**VILLAGE OF WINDSOR  
VILLAGE BOARD RESOLUTION 2024-04**

**APPROVAL OF SITE PLAN FOR A MULTI-TENANT COMMERCIAL BUILDING  
LOCATED AT 4150 SILO DRIVE**

## STAFF REPORT

To: Plan Commission & Village Board  
Cc: Robert Wipperfurth, Tina Butteris, & William Cole  
From: Shaun Mularkey & Jamie Rybarczyk  
Submtl Date: December 11, 2023  
Rpt Date: January 05, 2024  
Decision Date: March 10, 2024  
Mtg Date for PC: January 11, 2024  
Mtg Date for VB: January 18, 2024  
Re: Covered Bridge Commercial – Site Plan Review

1 ARCHITECTURAL SITE PLAN  
1" = 40'-0"

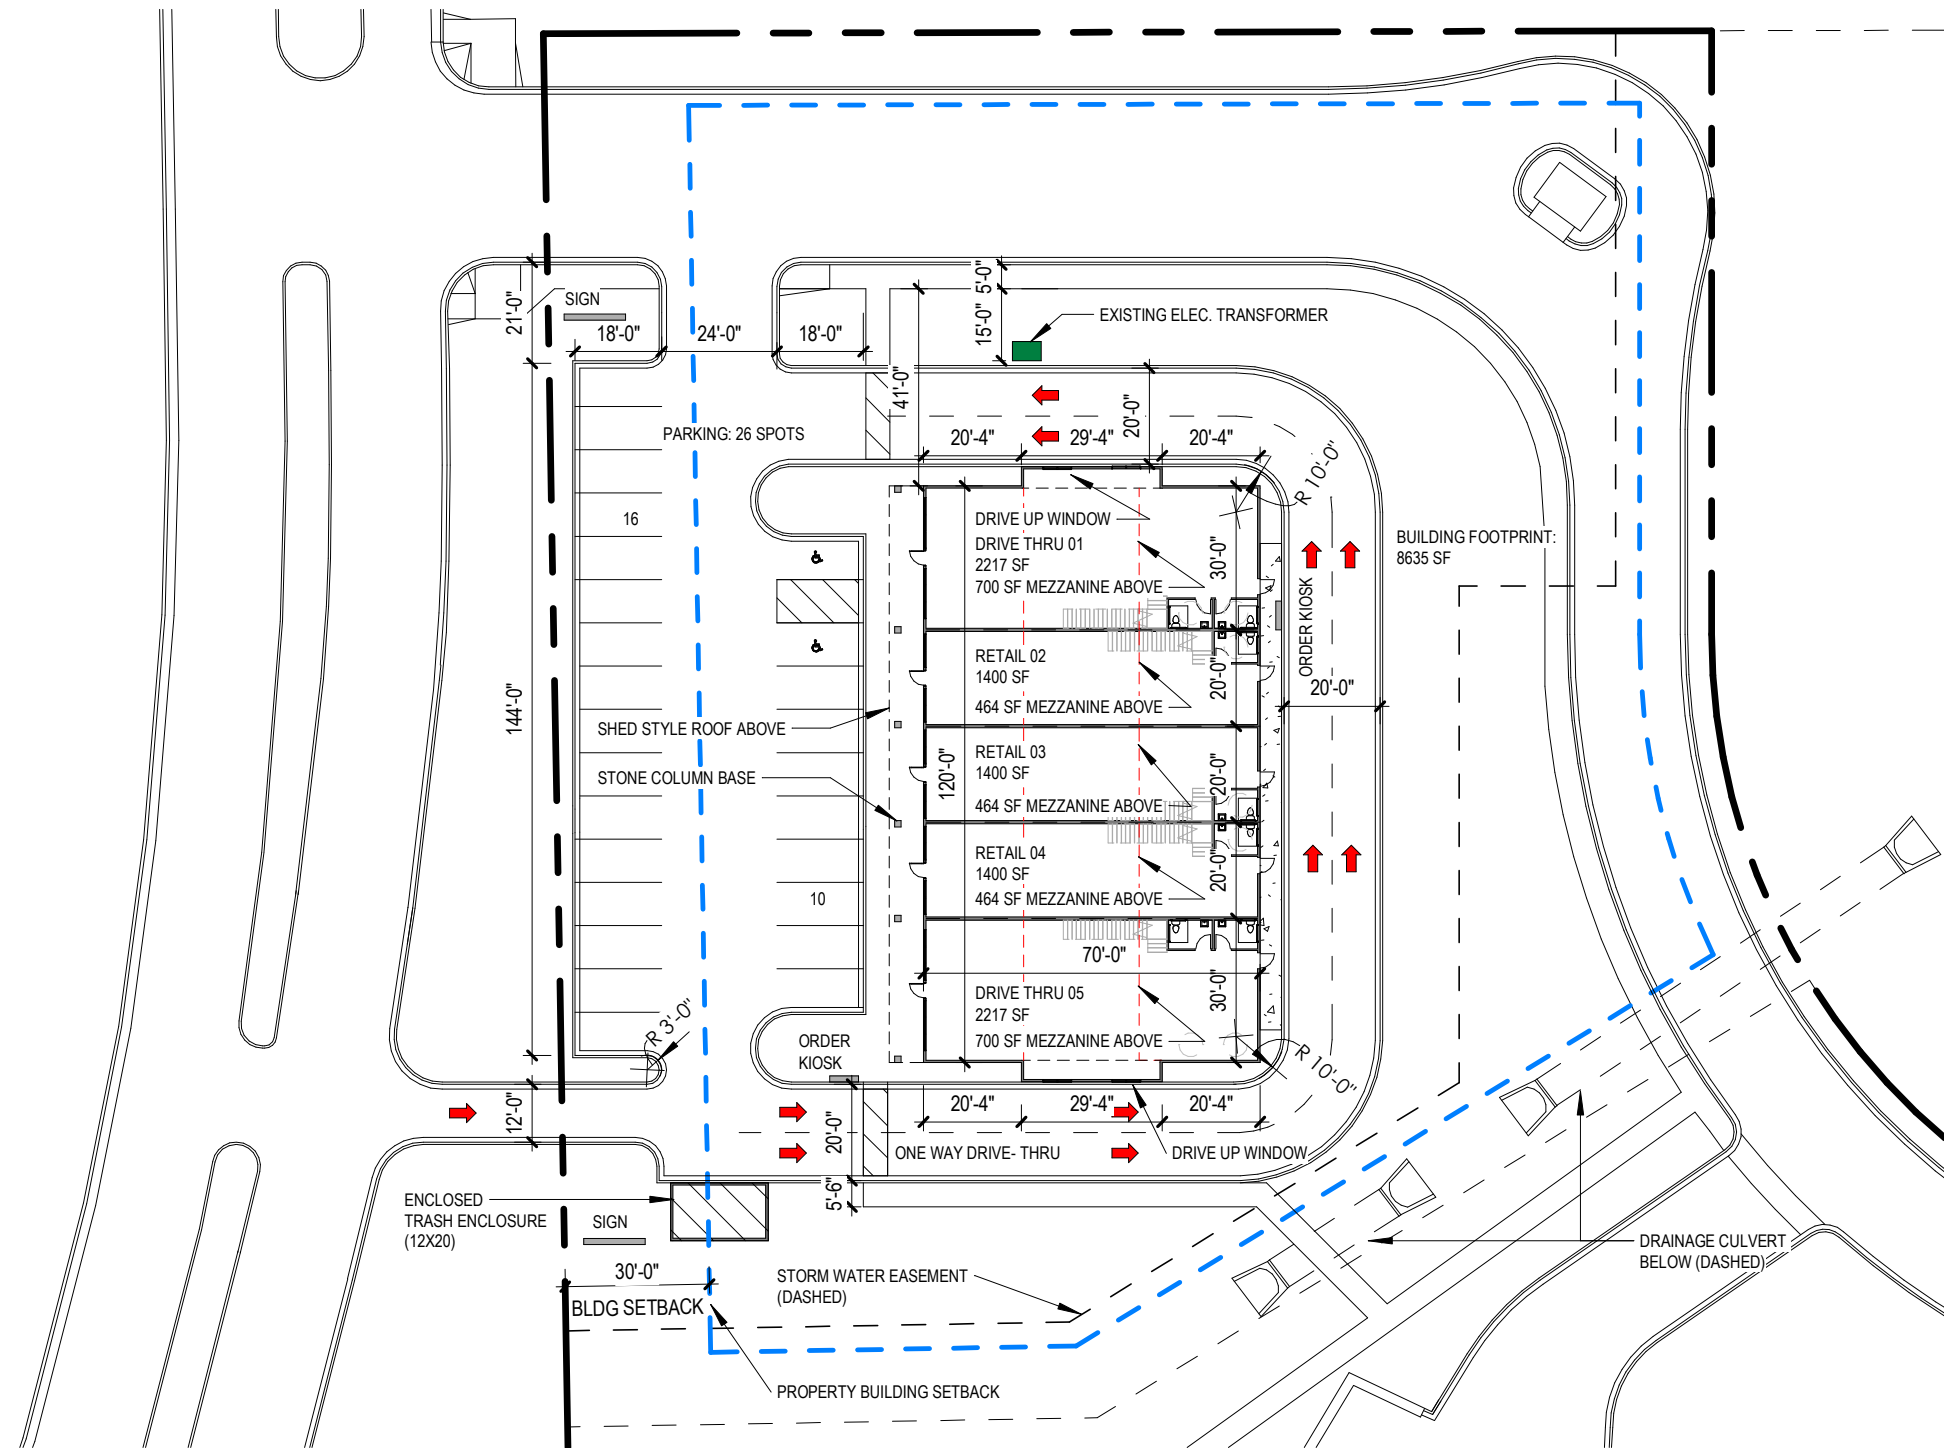
1. Sheet SD101
  - a. The one-way drive-through entrance off of the public street is shown as 12 feet wide. Given this width, we recommend the southern radius be increased in size to accommodate for longer vehicles.

- b. The one-way drive-through entrance off of the public street should align with the entrance to the Yahara River Learning Center to the west.
  - c. The existing multi-use path should be shown on the sheets, with the appropriate driveway crossings accommodated.

- d. The existing sewer and water mains in Pederson Crossing Boulevard should be shown, along with the existing associated laterals that are stubbed into the property.

- e. We noted that the parking stall count is shown as 26, while the earlier submittals (dated March 10, 2023) contemplated 29 stalls (for a slightly larger 10,000 square foot building).

- f. The trash enclosure is shown straddling the building setback line.
2. Sheet SD102 – A minor typo on the street label. This should read “Pederson Crossing Boulevard.”

1 FLOOR PLAN - DRIVE THRU  
3/32" = 1'-0"

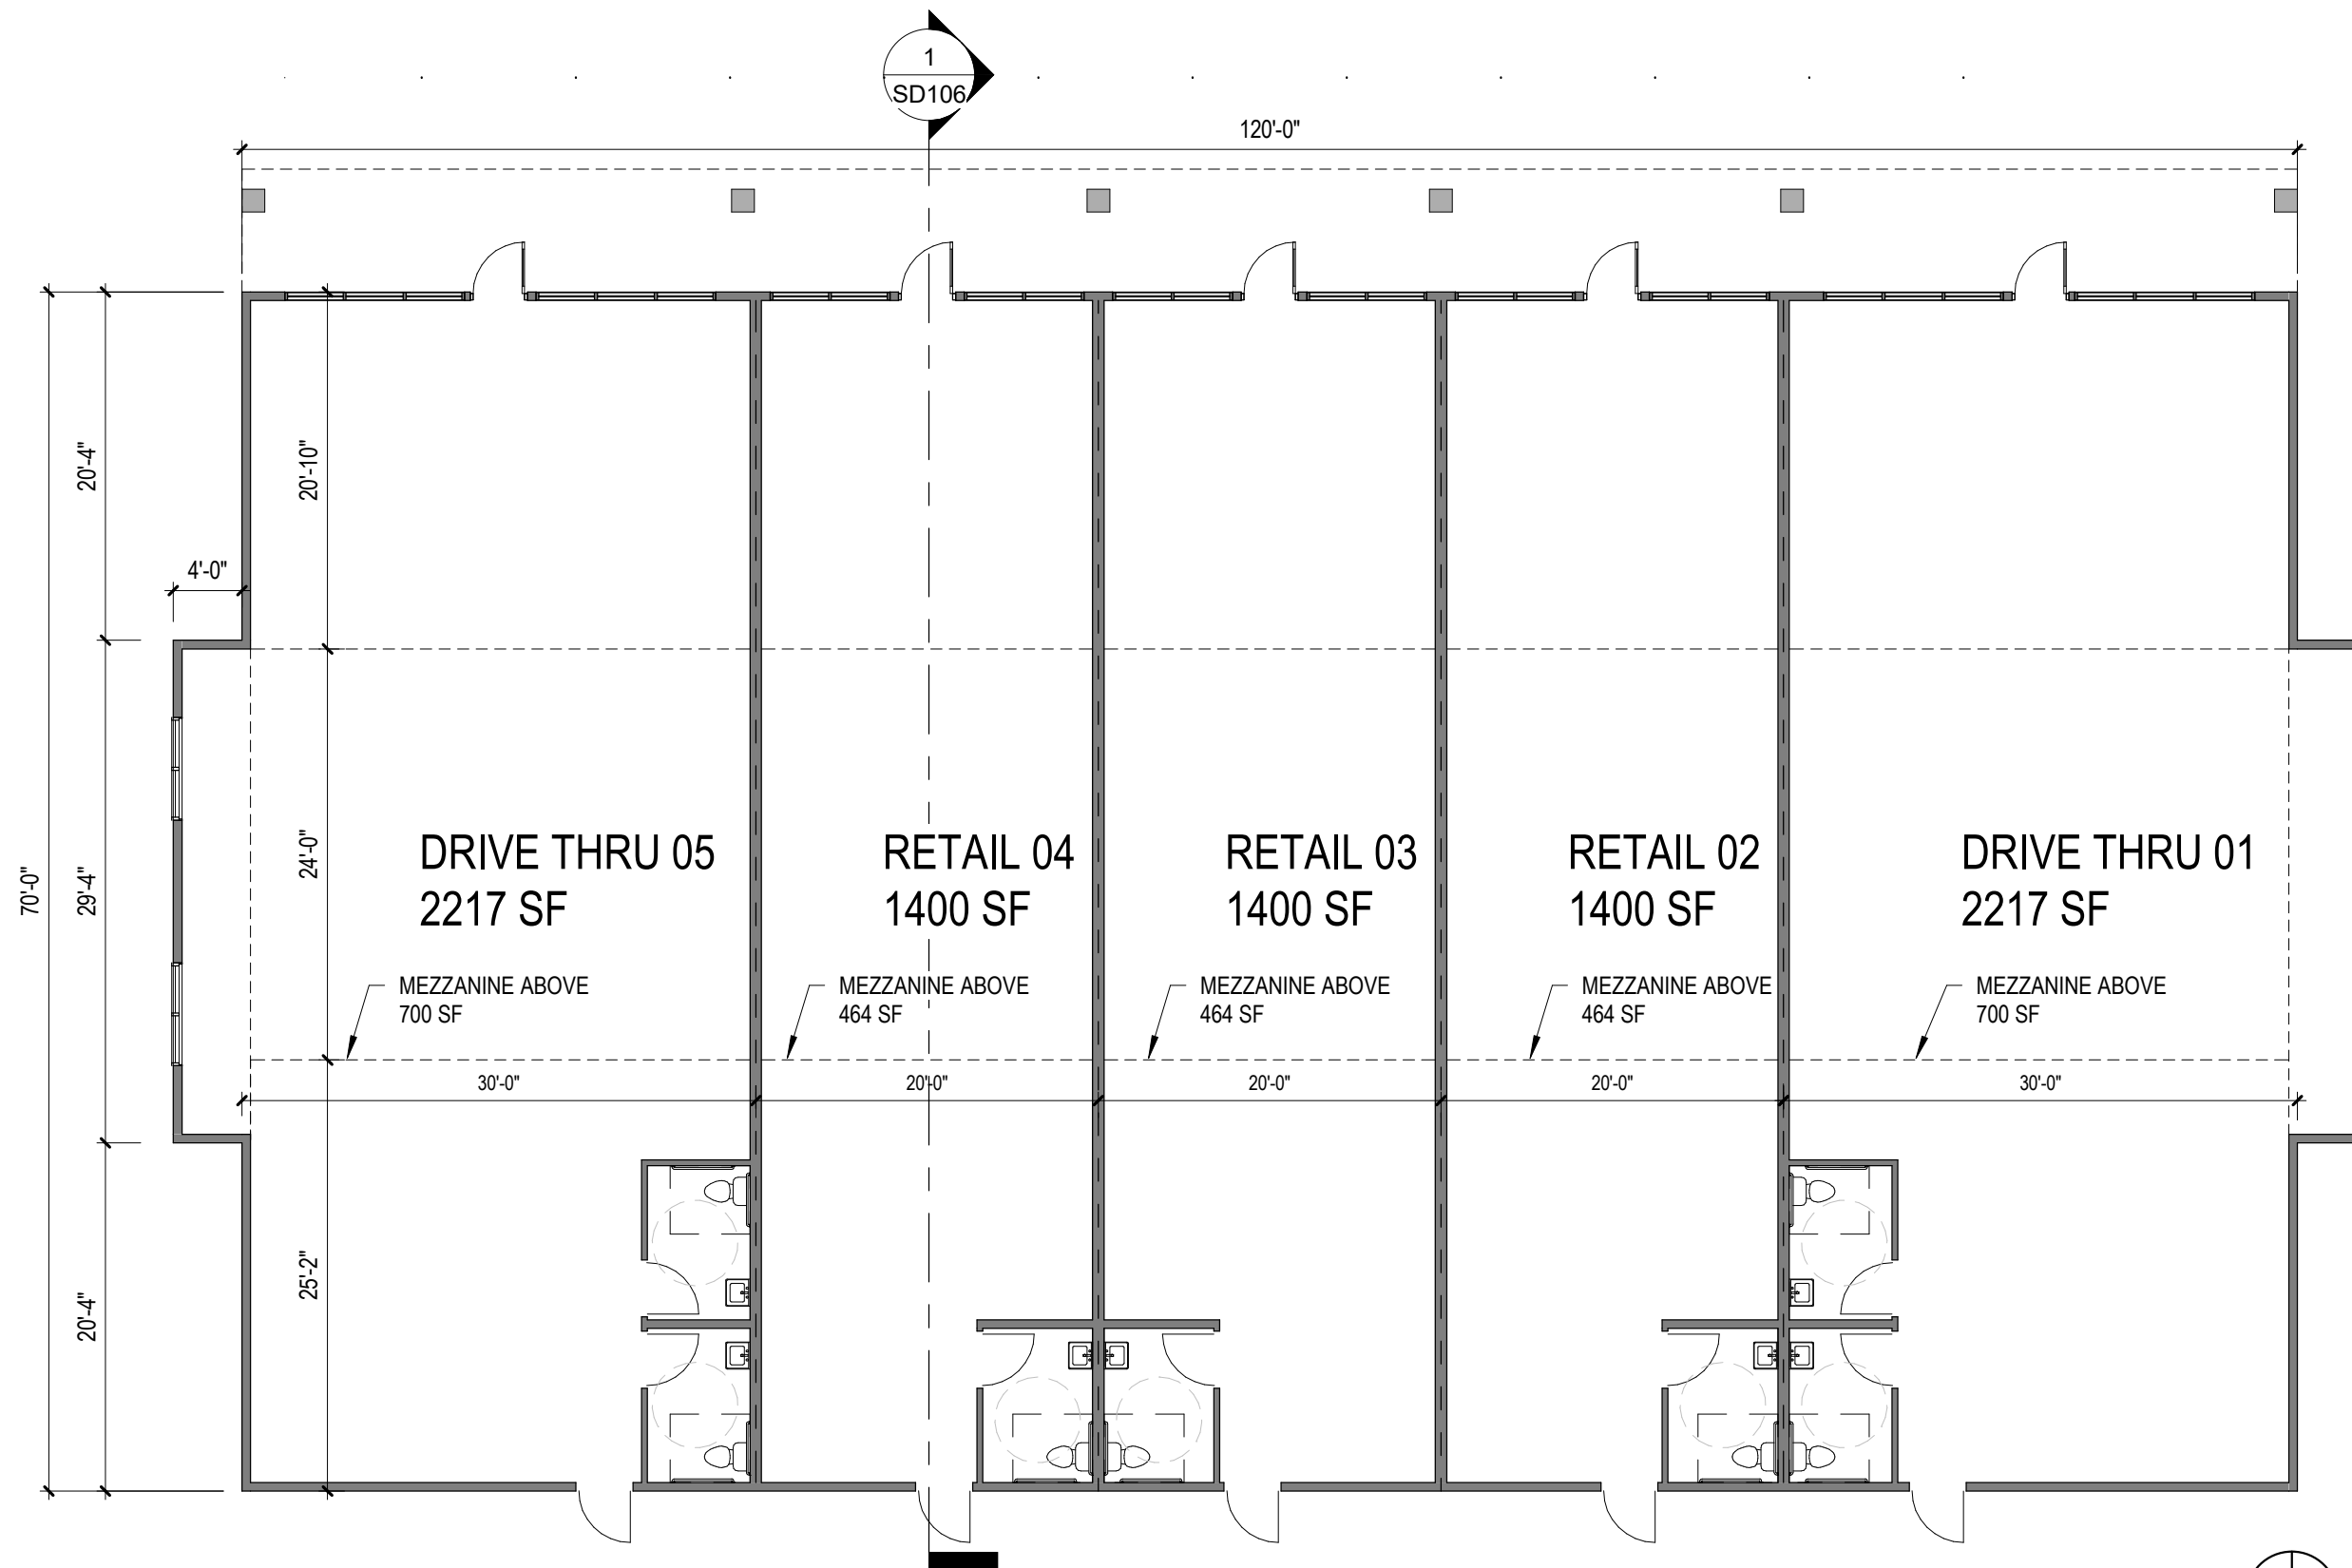
1. Circulation and access. The site includes drive through windows for each of the end units. There are two drive-through lanes that wrap around the south, east and north sides of the building. Only the interior lane services both of the drive through windows, so the exterior lane would be used to bypass queued vehicles. The order kiosk for the south unit is very close to the north-south driveway and can only accommodate one vehicle with impeding traffic from the south site entrance (one-way in). The Plan Commission and Village Board should determine if there is adequate queuing room for the south drive-through window given the order kiosk location.

- B. The Plan Commission and Village Board should determine if there is adequate queuing room for the south drive-through window given the order kiosk location.

The Plan Commission expressed concern over the queuing room for the south drive-through and felt that it only worked if the end-user was a non-restaurant use (i.e. dry cleaner) and that access is granted to Pederson Crossing Boulevard.
